PLANNING REPORT

Sycamore Ridge Apartments 23-054MPR

Address	6700 Sycamore Ridge Blvd, Dublin, OH 43017
Proposal	Modifications to fences for 210 units in an existing residential development in the Bridge Street District.
Request	Review and approval of a Minor Project Review under the provisions of Zoning Code Section 153.066.
Zoning	BSD-R, Bridge Street District – Residential
Planning Recommendation	<u>Approval of Minor Project Review</u> Planning recommends approval with conditions.
Next Steps	The Administrative Review Team (ART) is the final reviewing body for this application. Upon approval from the ART, the applicant may apply for a fence permit through Building Standards.
Applicant	Jeffrey Madison, Park Street Law Group
Case Managers	Zach Hounshell, Planner II (614) 410-4652 zhounshell@dublin.oh.us Jane Peuser, Planning Assistant (614) 410-4675 jpeuser@dublin.oh.us

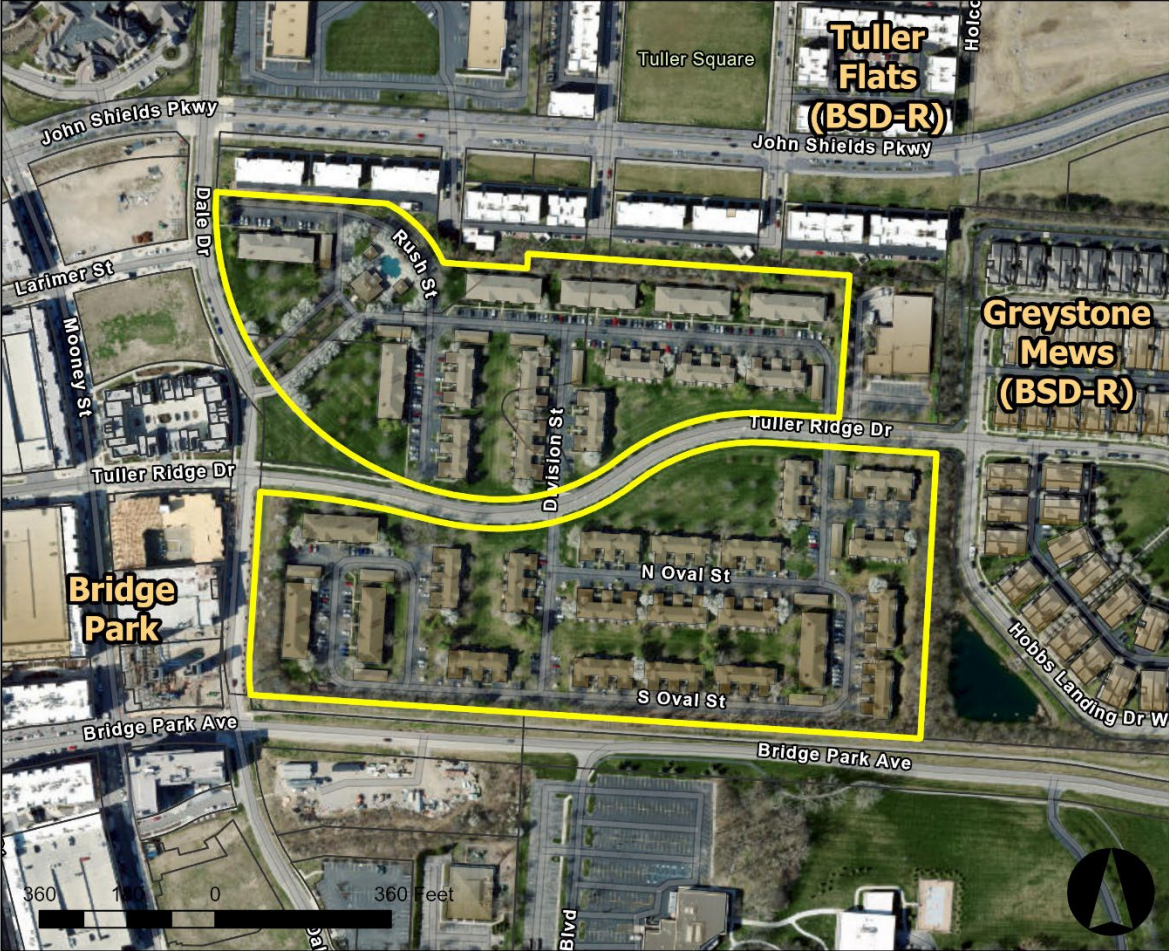
The applicant is proposing enclosing the black aluminum fences in the rear of each unit with gates. The typical dimensions provided are 18 feet of fencing perpendicular to the building and 17 feet parallel to the building face. New fencing would enclose a private courtyard for each of the 210 units. Staff recommends new fencing not extend further than the existing wood fence from each building.

No utility easements were noted on the submitted materials, but Staff is recommending a condition of approval that the applicant work with Staff to ensure that access to utilities on site is maintained.

- 1) The applicant work with Staff to assure that no fence will impact any existing utilities or utilities access for each unit; and
- 2) New fencing not extend further than the existing wood fence from each building.
